Docket Item # 3 and 4  
BAR CASE # 2011-0288 and  
2011-0289

BAR Meeting  
November 2, 2011

**ISSUE:** Permit to Demolish/Encapsulate and Alterations

**LOCATION:** 807 Oronoco Street

Figure 6. Proposed alterations to rear (north) elevation.

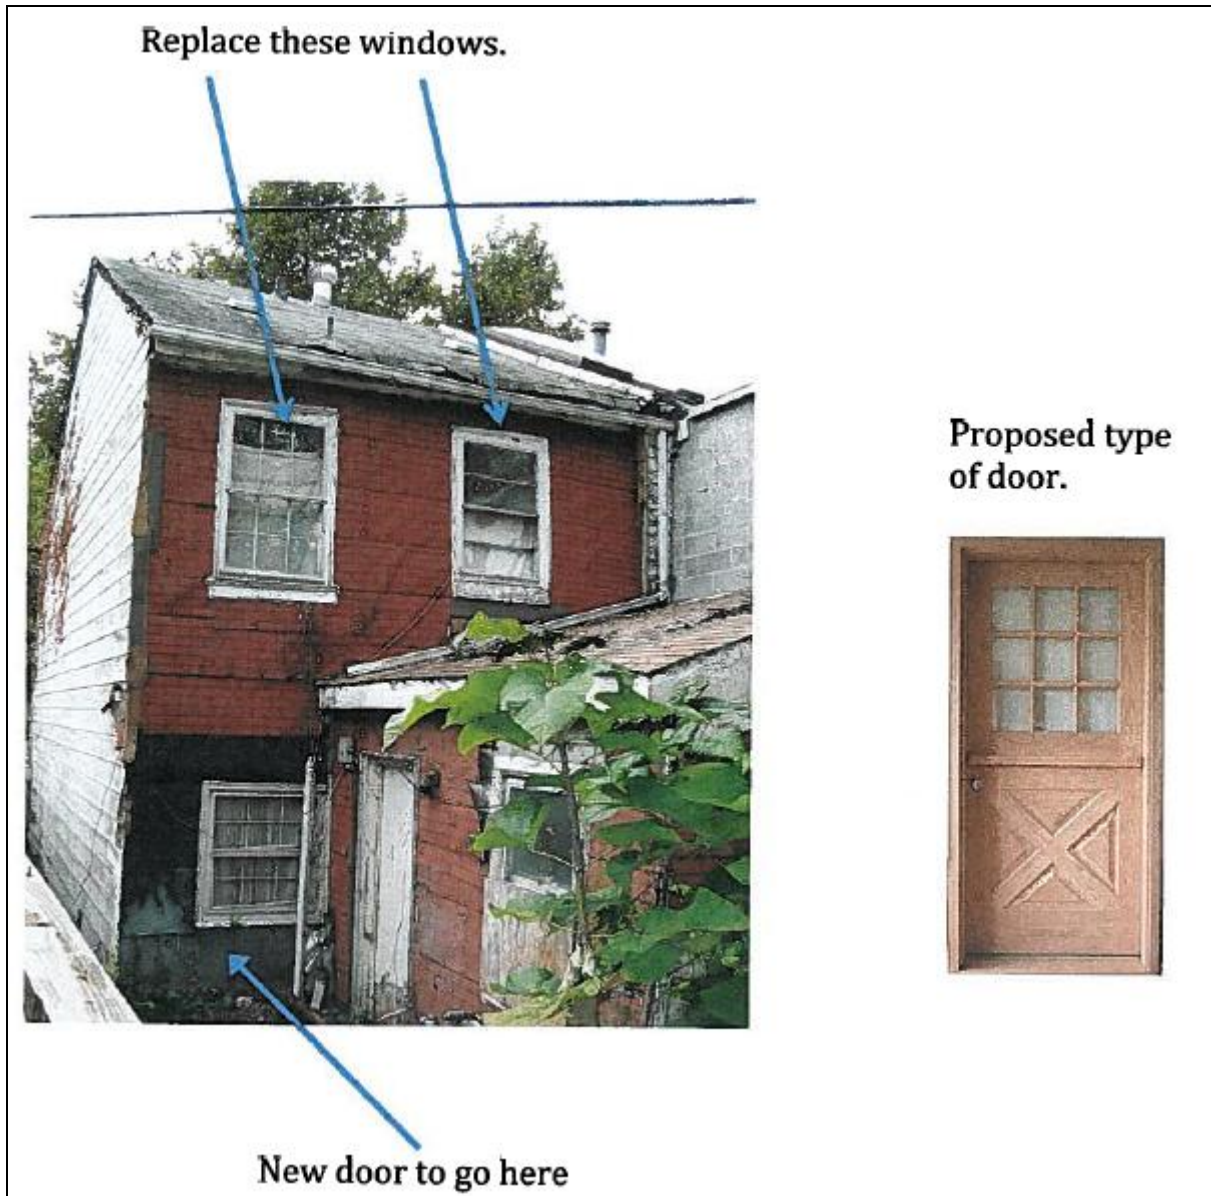
Therefore, in consideration of the phased approach to this project, the applicant proposes to properly frame and close in the rear of the main block once the one-story addition is demolished. While this elevation is minimally visible from a public right-of-way, the applicant will use historically appropriate wood siding and will convert the existing first story window into a door. The applicant proposes to replace the two existing windows on this elevation. The applicant does not propose to change the front elevation.

The rear (north) elevation is minimally visible from the public alley northeast of the property. Staff, therefore, supports “temporary” enclosure of a portion of the rear elevation of the main block with wood siding for the interim period before the applicant comes to the Board for an addition application. Staff also supports the changing the existing first story rear window to a door, noting that this represents a common type of utilitarian alteration found throughout the districts.

1. That the applicant work with Staff to determine if historic wood siding exists and can be salvaged and if replacement siding is necessary, in whole or in part, that it be historically appropriate wood siding.

2. That any replacement windows be in conformance with the Alexandria Replacement Window Performance Specifications.
3. The statements in archaeology conditions below shall appear in the General Notes of all site plans and on all site plan sheets that involve demolition or ground disturbance (including Basement/Foundation Plans, Demolition, Erosion and Sediment Control, Grading, Landscaping, Utilities, and Sheeting and Shoring) so that on-site contractors are aware of the requirements:
